## COUNCIL ASSESSMENT REPORT

<b>Panel Reference</b>	2017SNH034
<b>DA Number</b>	N0123/17
<b>LGA</b>	Northern Beaches Council
<b>Proposed Development</b>	Demolition of an existing aged care facility and construction of a new 156 bed aged care facility
<b>Street Address</b>	184 Garden Street, Warriewood
<b>Applicant/Owner</b>	Principal Healthcare Finance Pty Limited
<b>Date of DA lodgement</b>	7 April 2017
<b>Number of Submissions</b>	4
<b>Recommendation</b>	Approval, subject to conditions
<b>Regional Development Criteria</b>	Capital Investment Value > \$20 million
<b>List of all relevant s79C(1)(a) matters</b>	<ul style="list-style-type: none"> <li>• Environmental Planning and Assessment Act 1979</li> <li>• Environmental Planning and Assessment Regulation 2000</li> <li>• Roads Act 1993</li> <li>• Rural Fires Act 1997</li> <li>• State Environmental Planning Policy (Housing for Seniors and People with a Disability) 2004</li> <li>• State Environmental Planning Policy No.55 – Remediation of Land</li> <li>• Pittwater Local Environmental Plan 2014</li> <li>• Pittwater 21 Development Control Plan</li> <li>• Warriewood Valley Strategic Review Report 2012</li> <li>• Warriewood Valley Strate

**Figure 2 – Construction staging diagram**  
Source: Group GSA Pty Ltd

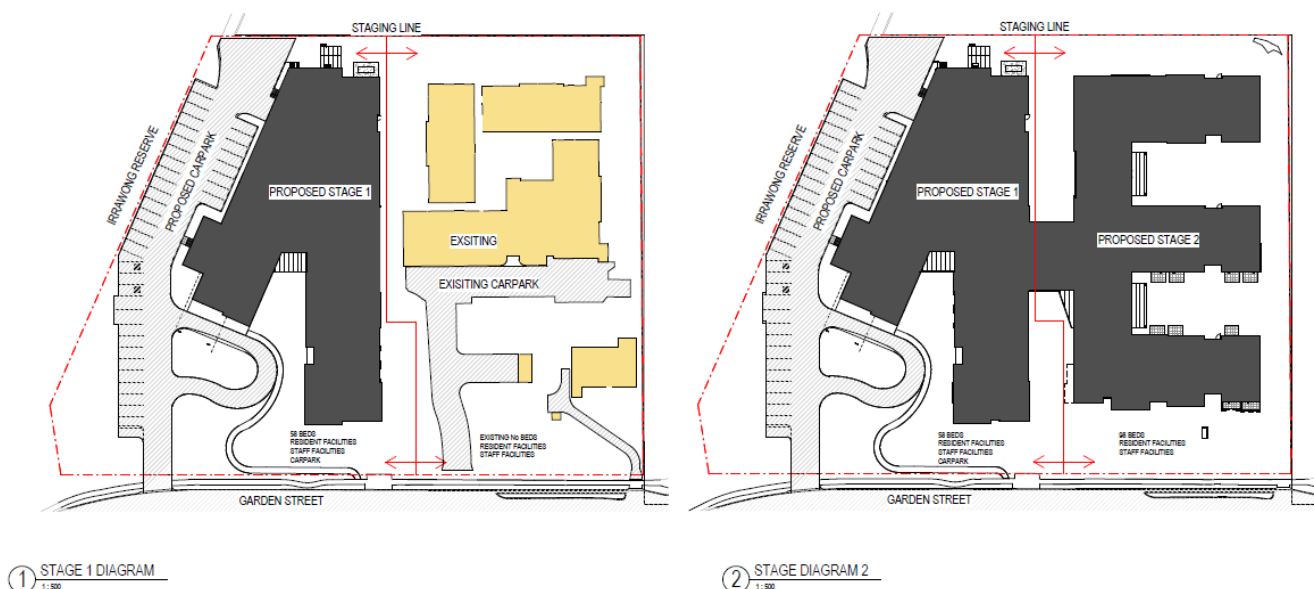
The applicant seeks to undertake the demolition and construction works in two separate stages, as nominated in **Figure 2**, below. The existing driveway, carpark and northern portion of the residential care facility will continue to operate whilst the Stage 1 works are undertaken and once the Stage 1 works are operational, Stage 2 works will commence.

12. The staging of the development of the site is to be consistent with the approved Staging Plan referenced in this consent, in addition to the following:

8. An approved Staging Plan referenced in this consent is to be amended prior to the issuance of the first Construction Certificate to specifically demonstrate the following:
